KASAAN HARBOR IMPROVEMENTS
KASAAN, ALASKA

PROJECT No. 67953

As-Built PLANS
CONTRACTOR: Pool Engineering, Inc.
PROJECT ENGINEER: Kraig Norheim
BEGIN DATE: April 4, 2012
END DATE: September 19, 2012

GRATING PLAN @ BREAKWATER FLOAT
REF. DWG# E1 REV. 2, 1 REV. 2, 5 REV. 2
SCALE: ⅜"=1'-0"

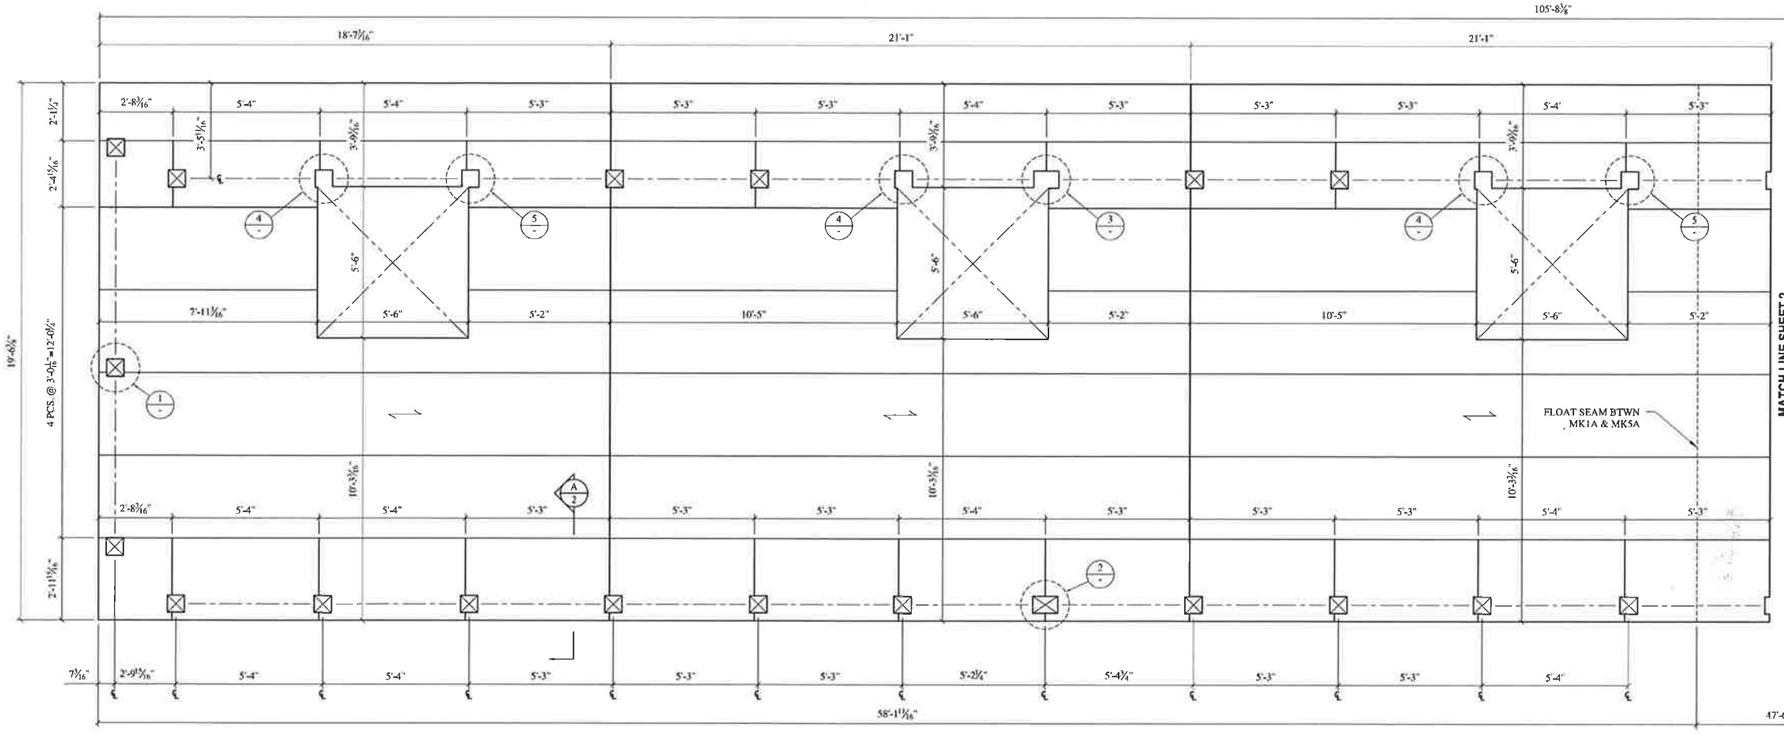
No Scupper Cutouts Req'd. Bullrail will be too close to grating. If deviation from plans, provide justification for change.

GRATING PLAN @
BREAKWATER FLOAT
REF. DWG# E1 REV. 2, 1 REV. 2, 5 REV. 2
SCALE: ⅜"=1'-0"

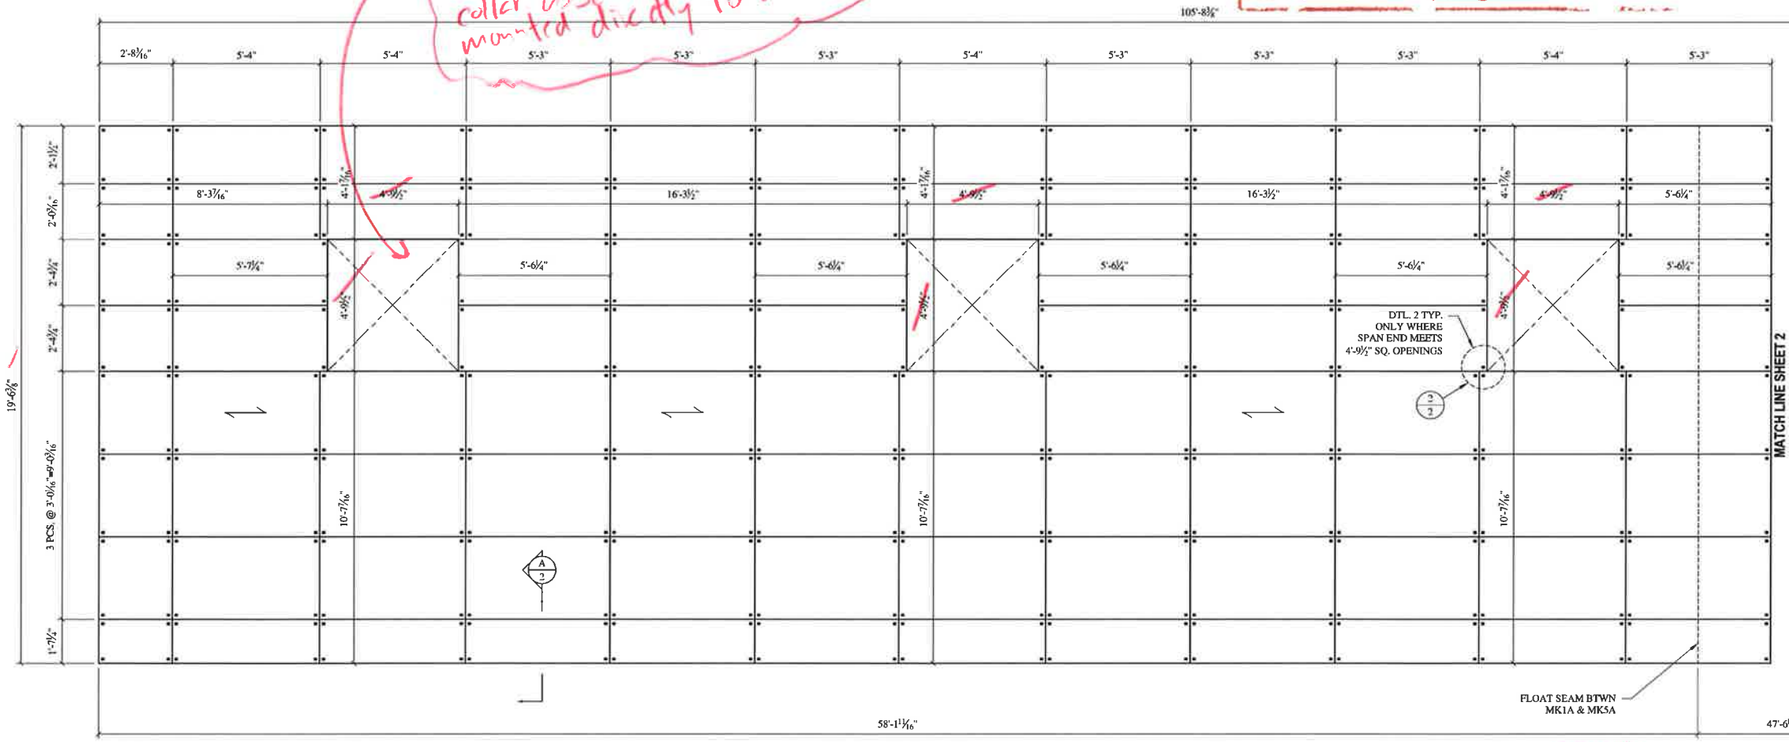
Pile Collar Blackout needs to be larger so collar assembly can be mounted directly to deck beam

* See Sheet 6 of planset for weld lugs ~~anchor blok~~ details. A tolerance of ± ¼" will not provide proper alignment w/ studs & bolt holes
* Max spacing for ~~anchor~~ weld lugs 1'-0" O.C. per note on sheet 6.
* What about blockouts for bullrail bolts?

MAKE 2 ~ AS SHOWN ~ MC18X42.7 X 34'-5 3/16" ~ MK 8A^{R}

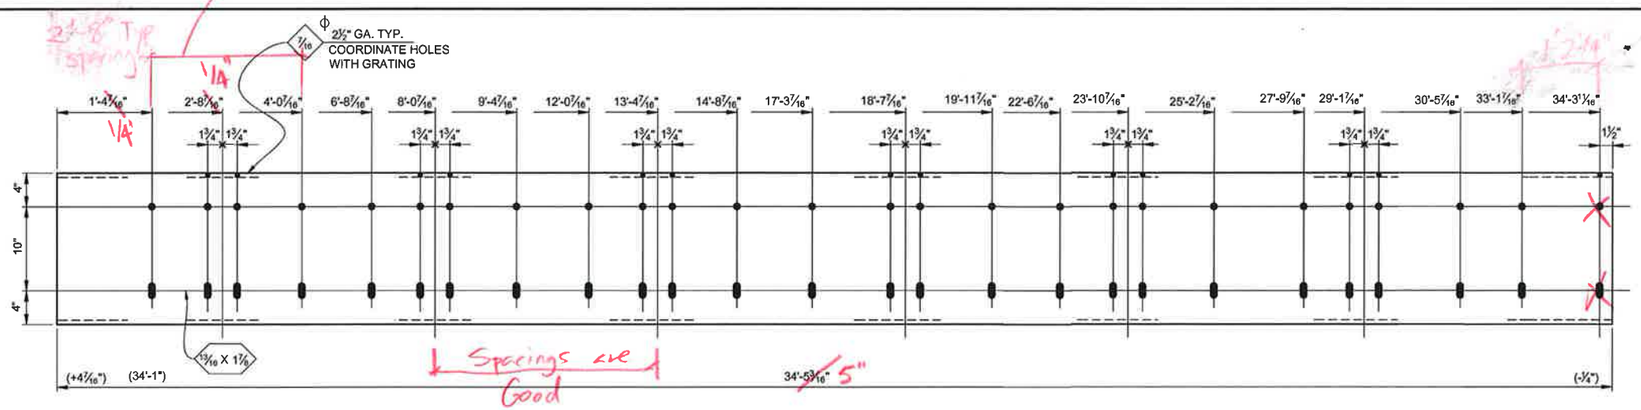
Spacings are good

PAGE DESCRIPTION: 10X50' FLOAT SECTION

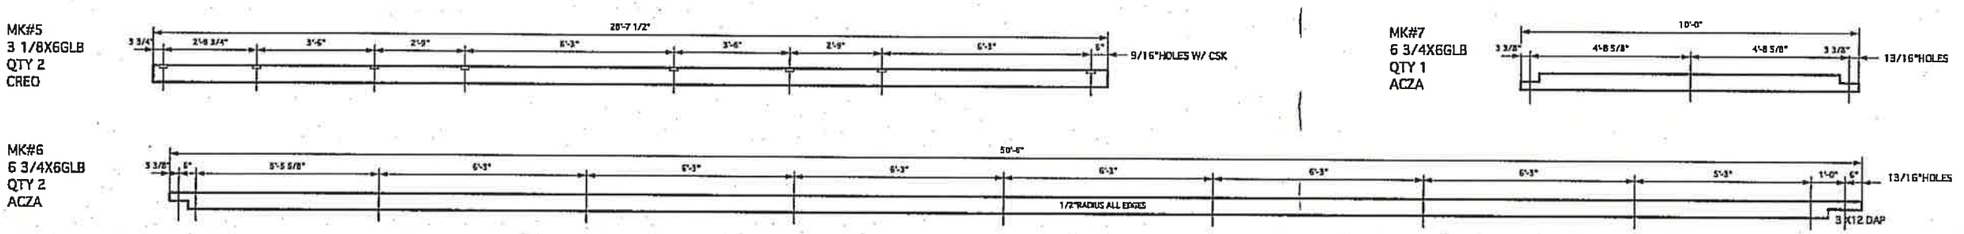
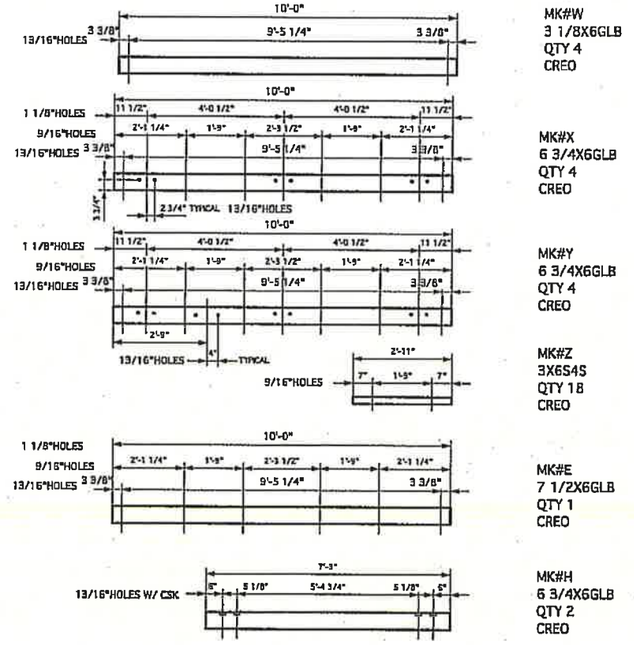
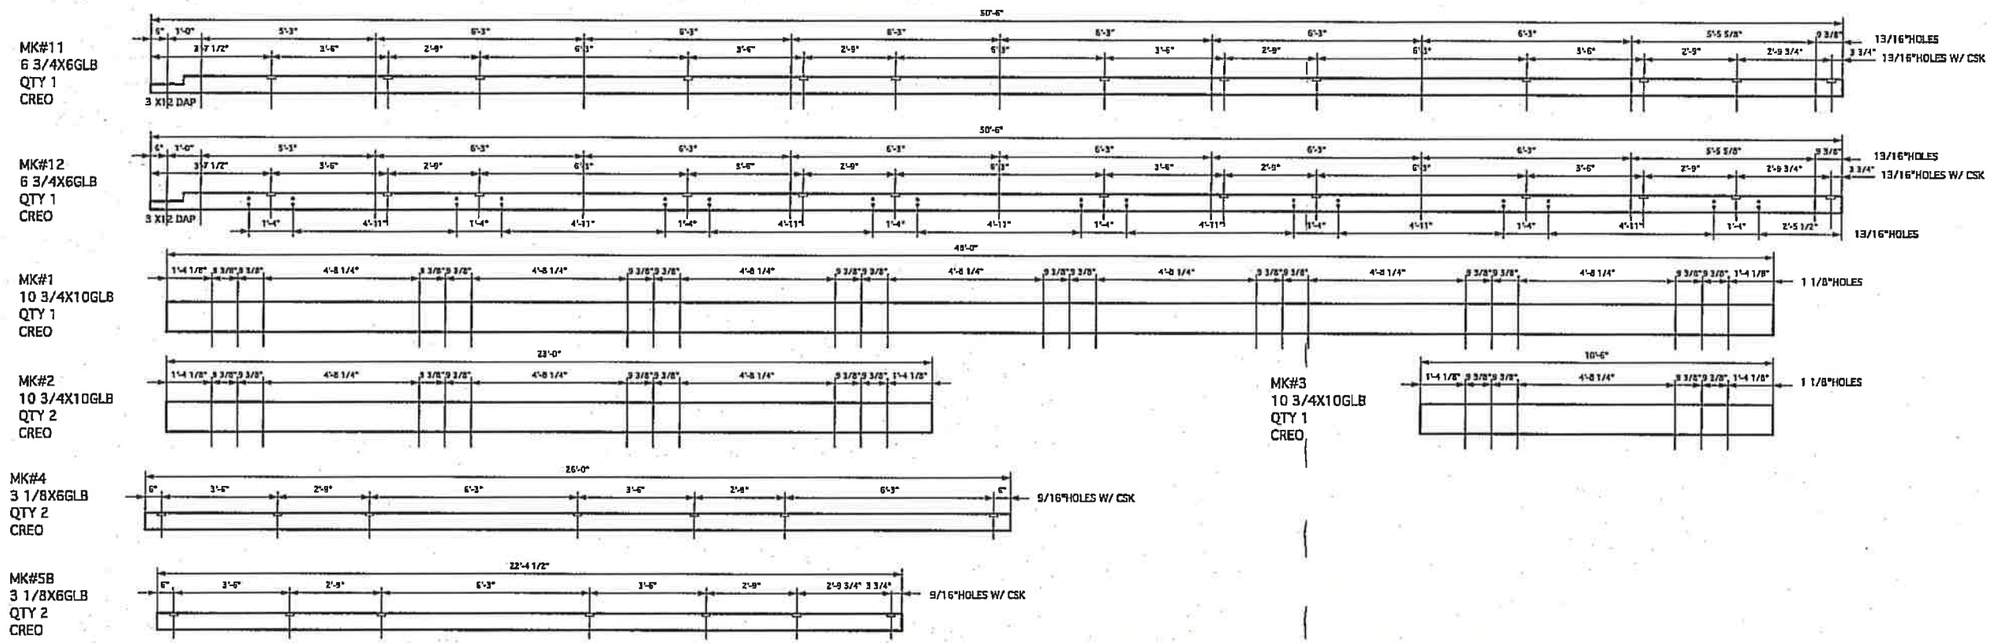
(Revise Figure one to above)
(Flip - Flop)

PAGE DESCRIPTION: 12X50' FLOAT SECTION

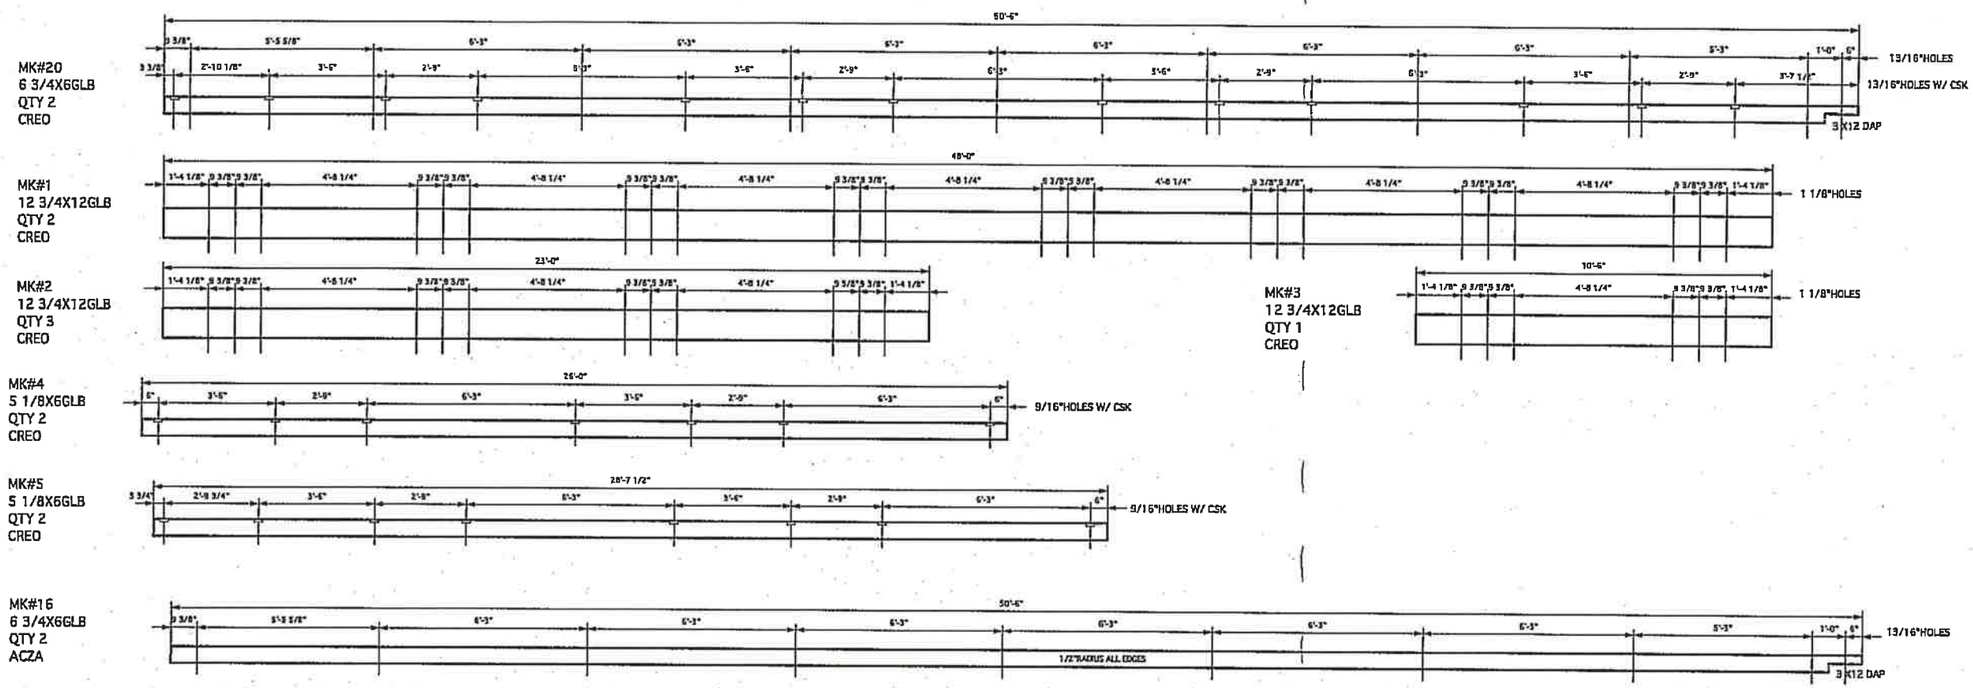
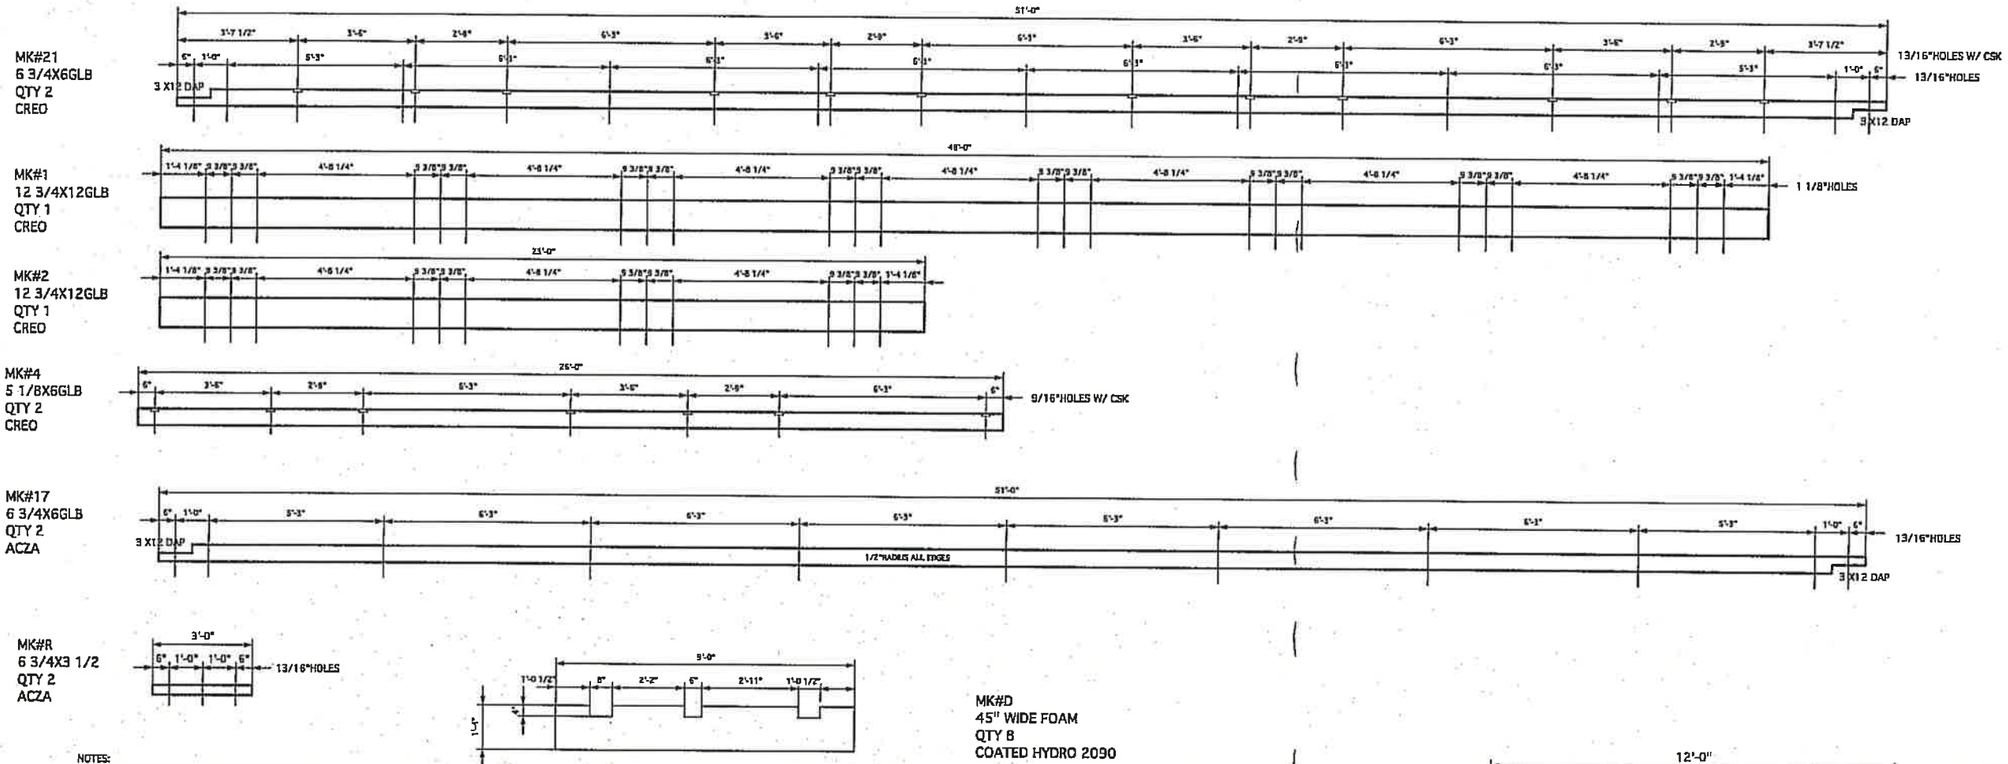
(Revise Figure one)
(Flip - Flop)
